Access Compliance Report

Public Rights-of-Way

Intersection ID: 15806	Main Street: EAST_BV	Cross Street: MARYLAND_AV	Location:	N
ADA ID: 098B4F486331	Ramp Type: Perp	Initial Pass/Fail: Fail	Overall Compliance: No	Severity Score: 12.5
Codes/Mitigation Info/Possible Solution		Field Measurements/Component Compliance

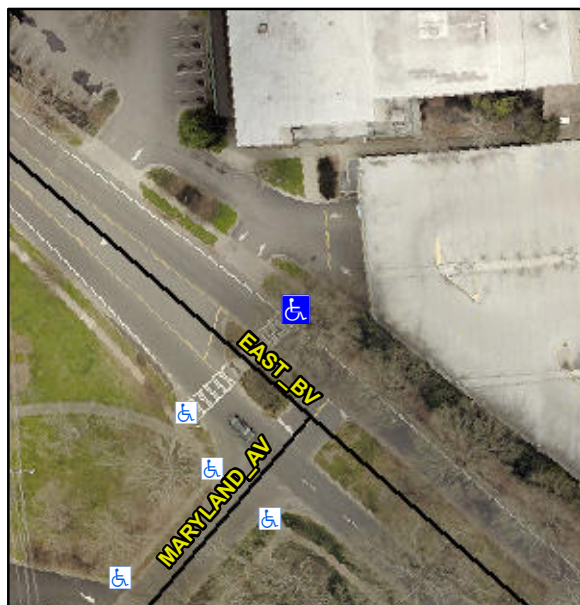
Not Found, R304.2.2

Compliance	Description	Data	Compliance	Description	Data
N/A	Ramp Length (in)	118.0	No	Ramp Slope (%)	10.2
Yes	Ramp Width (in)	73.0	Yes	Ramp XSlope (%)	0.4
N/A	Flare Type LT	N/A	N/A	Flare Type RT	N/A
N/A	Flare Slope LT (%)	N/A	N/A	Flare Slope RT (%)	N/A
N/A	Flare Traversable LT?	N/A	N/A	Flare Traversable RT?	N/A
N/A	Landing Length (in)	N/A	N/A	DWS Provided?	N/A
N/A	Landing Width (in)	N/A	N/A	DWS Contrast?	N/A
N/A	Landing Slope (%)	N/A	N/A	DWS Length (in)	N/A
N/A	Landing X Slope (%)	N/A	N/A	DWS Full Width?	N/A
N/A	Landing Curb? (Y/N)	N/A	N/A	DWS Offset (in)	N/A
N/A	Shared Landing?	N/A			
N/A	Gutter Ponding?	N/A	N/A	Gutter Slope (%)	N/A
N/A	Gutter Lip Ht (in)	N/A	N/A	Gutter X Slope (%)	N/A
N/A	Painted X Walk1?	Yes	N/A	Painted X Walk2?	N/A
	X Walk 1 Direction	To SW		X Walk 2 Direction	N/A
N/A	X Walk 1 Width (in)	113.0	N/A	X Walk 2 Width (in)	N/A
	X Walk 1 Slope (%)	5.4		X Walk 2 Slope (%)	N/A
	X Walk 1 X Slope (%)	0.4		X Walk 2 X Slope (%)	N/A

Remove & Replace Entire Ramp.
